A47 North Tuddenham to Easton

9.24 Applicant's Response to the Examining Authority's Third Written Questions (ExQ3)

December 2021

**9.24 APPLICANT'S RESPONSE TO THE EXAMINING AUTHORITY'S
THIRD WRITTEN QUESTIONS (ExQ3)**

DRAWING TITLE
WOOD LANE JUNCTION LONG SECTION A-'A' MAINLINE CHAINAGE 4+500M

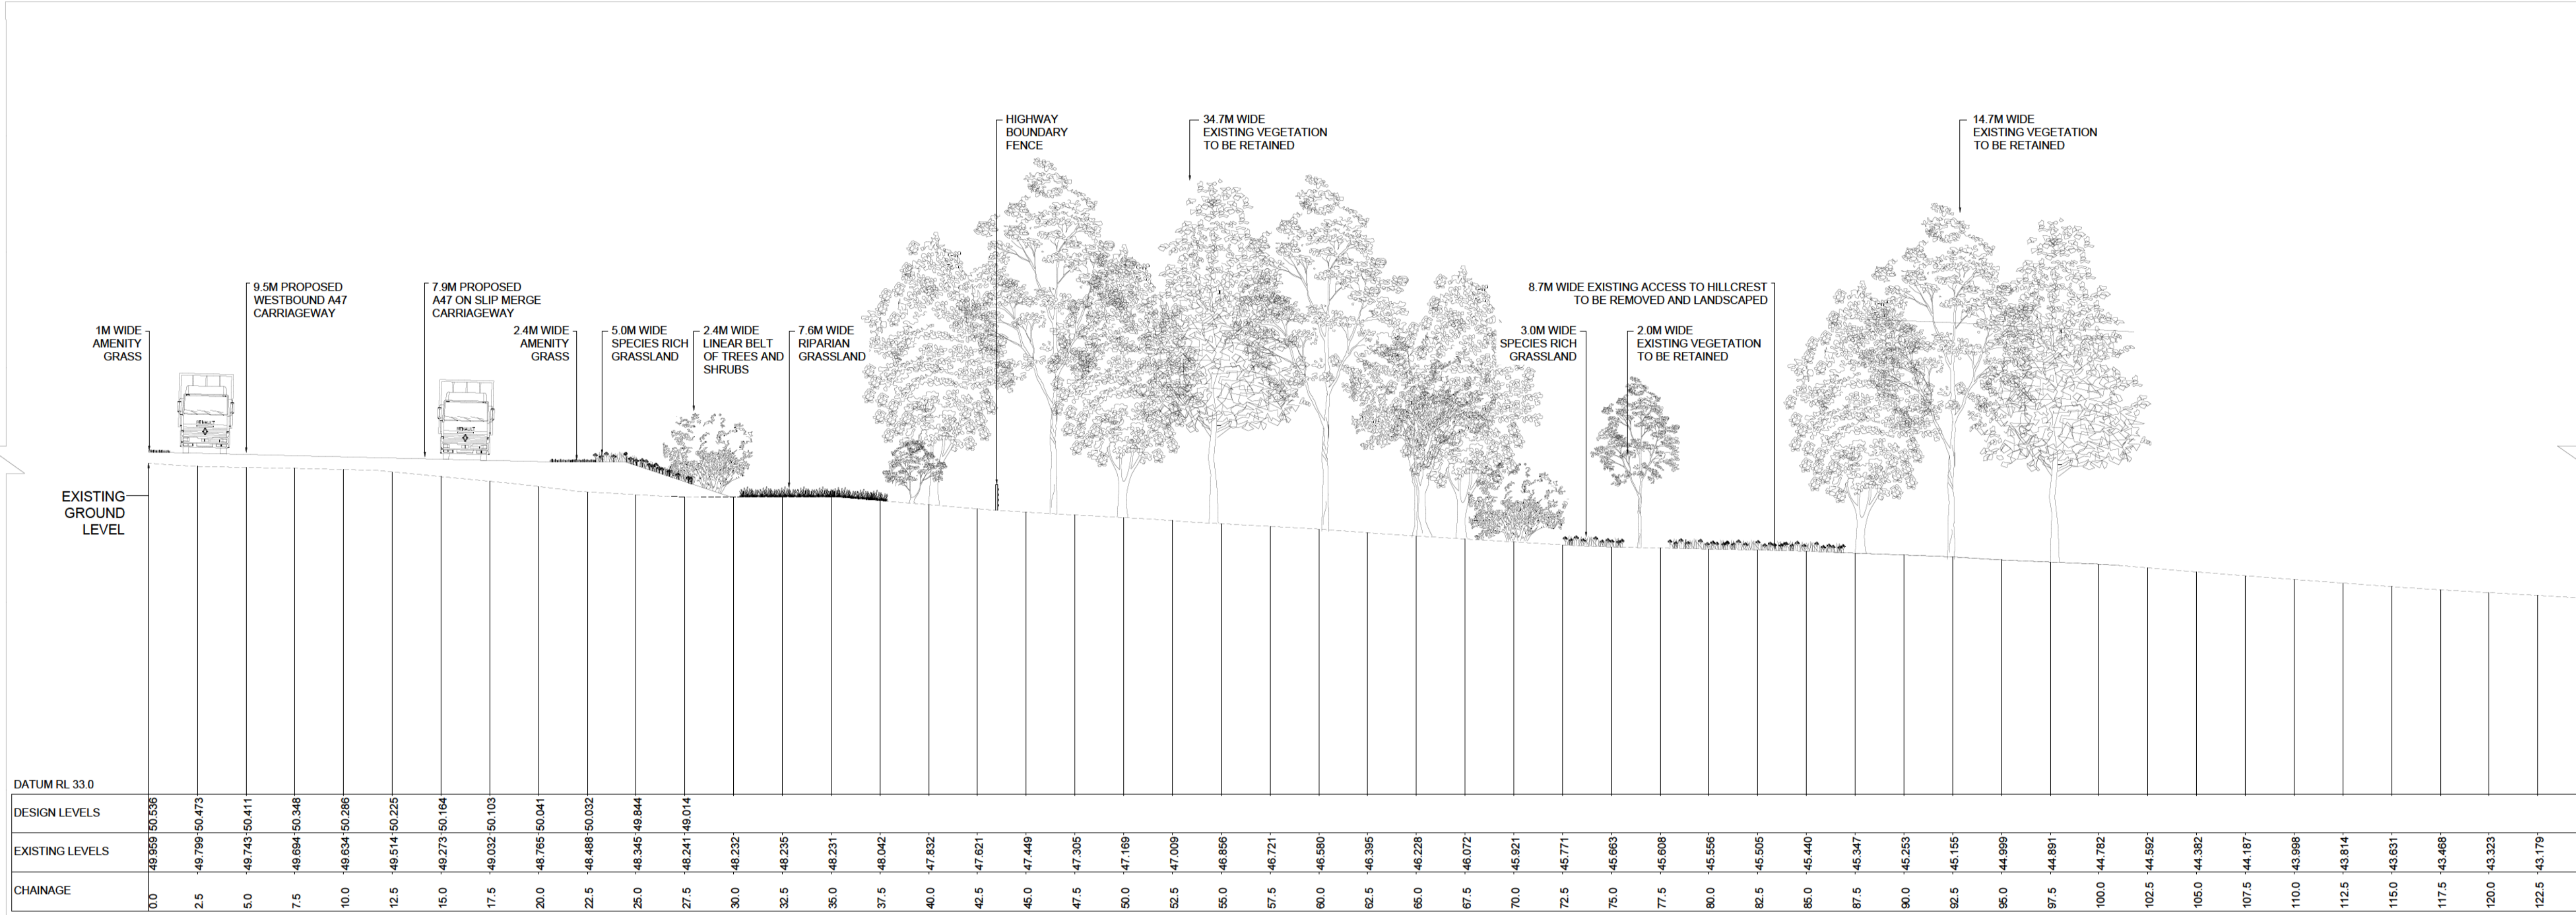
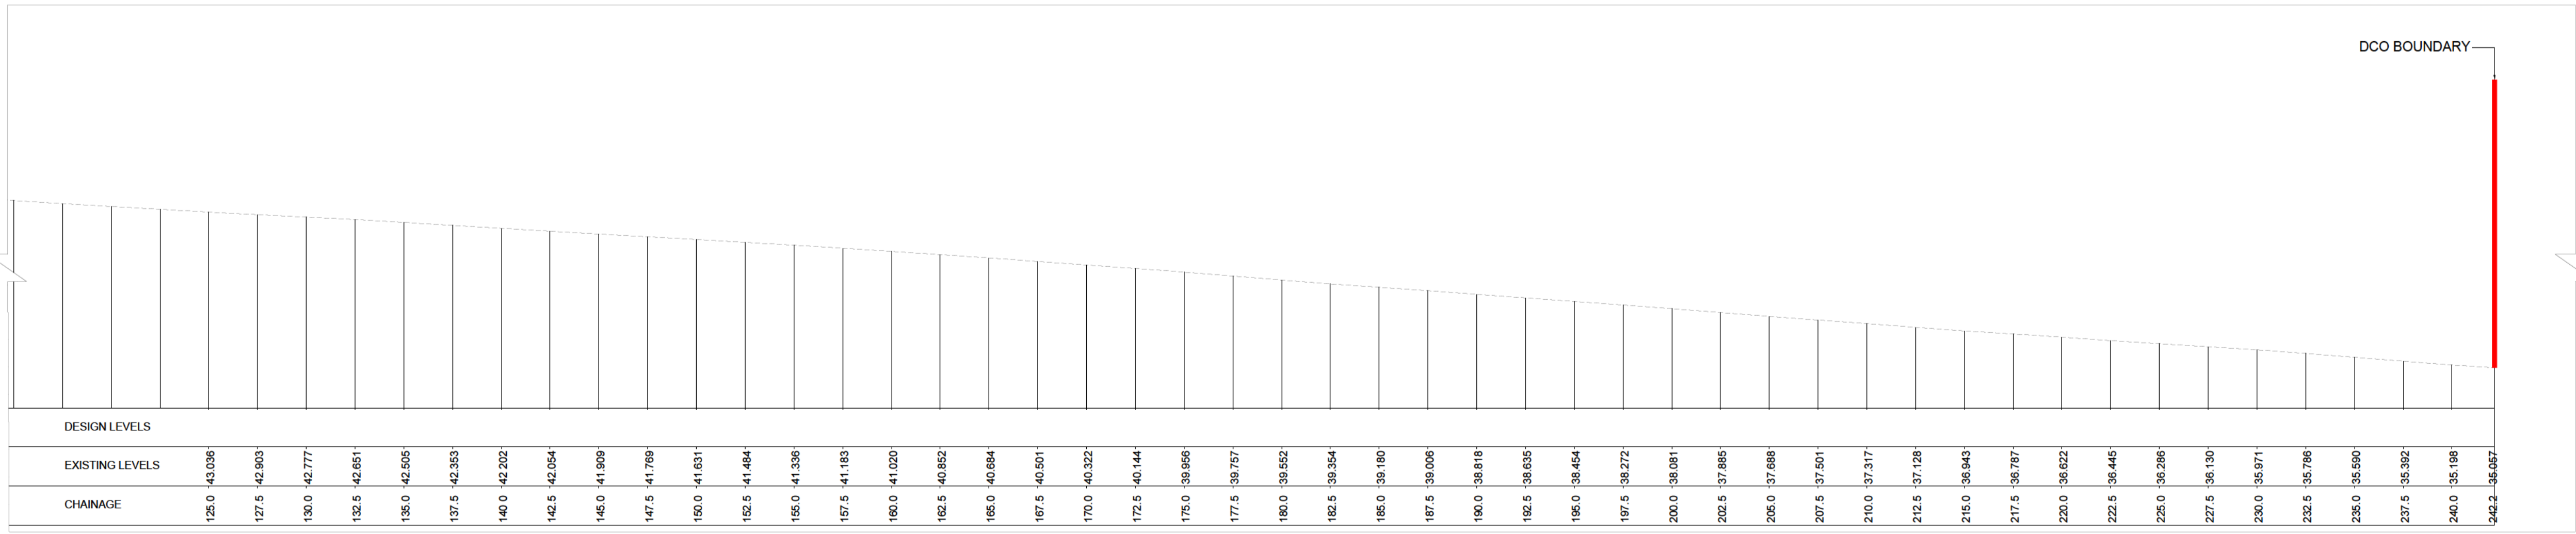
No	Question To	ExA Question	Response
Q10.3.1	The Applicant	Paragraph 3.4.14 of ES Chapter 3, Assessment of alternatives [APP-042], when discussing alternatives, identifies that the final junction design also took into consideration various constraints, such as the landscape setting of the Grade II listed Berry Hall. Please explain this statement and provide evidence to demonstrate how this was taken into account.	<p>The Scheme alignment (A47 Mainline) traverses along a route of predominantly sidelong ground (where the route runs along the side of a hill / slope naturally falling north to south) and has been designed to sit nominally above or below existing ground level to minimise visual intrusion into the existing landscape setting / environment. This aligns with the principle of "Good Road Design Fits in Context".</p> <p>In this scenario the Applicant could have chosen to either have the Wood Lane junction as an overbridge (above the A47) or underbridge (below the A47).</p> <p>The decision was taken to set the junction below the A47 mainline, which reduced impacts on the Parishes of Hockering and Honingham as well as the Berry Hall Estate, as follows:</p> <ul style="list-style-type: none"> • Reduced landscape / visual impact <ul style="list-style-type: none"> ○ Setting of overbridge ○ Headlight glare from vehicles on an elevated overbridge and slip roads • Reduced landtake • Reduced impact on Berry Hall Estate • Retained more existing vegetation • Reduced noise effects • Reduced impact of lighting on Hockering, Honingham and Berry Hall <p>The Applicant provided a response to a stakeholder query which is covered within the Consultation Report Annex N (APP-038), on pages 86 and 87.</p> <p>The final junction design has taken into consideration the findings from the environmental assessments. The reference to 'landscape setting of the Grade II listed Berry Hall' mainly relates to the heritage setting. However, the effects on Berry Hall Estate and its listed buildings as Heritage, Visual and Landscape constraints were considered in ES Chapter 6 – Cultural Heritage (APP-045) and ES Chapter 7 Landscape and Visual Effects (APP-046).</p> <p>In ES Chapter 6, Berry Hall Estate is assessed as part of the setting of the listed buildings.</p>

No	Question To	ExA Question	Response
			<p>Berry Hall was assessed as of "High value" and the setting was assessed as making a moderate positive contribution to that value. The Slight residual adverse effect on the setting Berry Hall Grade II Listed Building was identified as a result of construction and operation activities, after mitigation measures are implemented.</p> <p>With regards the scenic status, ES Chapter 7 identifies, assesses and proposes mitigation for the likely effects (both adverse and beneficial) of the Scheme on landscape character, landscape features and visual receptors.</p> <p>Screening for visual and noise purposes is provided where required as identified by the assessments undertaken in Chapter 7 Landscape & Visual (APP-046) and Chapter 11 Noise & Vibration (APP-051). In the Berry Hall area, the assessments indicated there is no requirement for the provision of such mitigation infrastructure for these topics.</p> <p>The noise assessment assessed the noise impact on Berry Hall for the Scheme as minor adverse in the short term (scheme opening for operation). This would improve in the long term (15 years-time) to negligible. It was concluded that this noise impact was not significant.</p> <p>Impacts from operational sources, such as light and traffic noise, on the heritage setting of Berry Hall due to the operation of Wood Lane junction are assessed as minor adverse magnitude on a high value asset.</p> <p>The proposed planting layout would reduce the predicted adverse impacts of the new proposed junction and traffic on the setting of nearby heritage assets including the Grade II listed Berry Hall (NHLE1306730). The Environmental Masterplan, Rev.2, (REP3-016) presents additional woodland planting to maintain the belt of woodland that screens views of the existing A47 from within the grounds of Berry Hall to include the new junction layout. This is reinforced by commitment CH1 in the Environmental Management Plan (APP-143), which states that the landscape planting design will be sensitive to the setting of heritage receptors such as Berry Hall. This would include consideration of spacing, species and scale, with appropriate recommendations carried forward into the maintenance regime at completion.</p> <p>The Applicant has provided eight cross sections (Section A-A to H-H) through the proposed A47 Mainline and Wood Lane Junction to demonstrate graphically how the scheme design sits within the existing landscape and also illustrating the Environmental Masterplan planting regime.</p> <p>These are included within Appendix A of this response document - Cross Sections of views from Berry Hall Estate.</p> <p>In addition to considering the ES findings, following the statutory consultation in February to April 2020, the Applicant considered the responses received from Affected Persons and, those received from the Berry Hall Estate. As set out in reply to Q5.0.9 in the 'Applicant's Response to the Examining Authority's First Written Questions (ExQ1)' (REP2-014), the Applicant has made several changes to the Scheme to reduce the impact on Berry Hall Estate.</p> <p>Amongst these, the following pre-application design changes specifically reduced adverse effects of the Scheme on the landscape and setting of Berry Hall:</p> <ul style="list-style-type: none"> • Reduced the length of the National Grid Gas pipeline diversion works so as to keep the gas pipeline diversion works east of Berrys Lane, instead of within the landscaped parkland to the south-east of Berry Hall. • The Scheme was redesigned in the vicinity of Berrys Lane to remove an access road from the Wood Lane junction directly on to Berrys Lane. This reduced the impact on the heritage setting of Berry Hall.
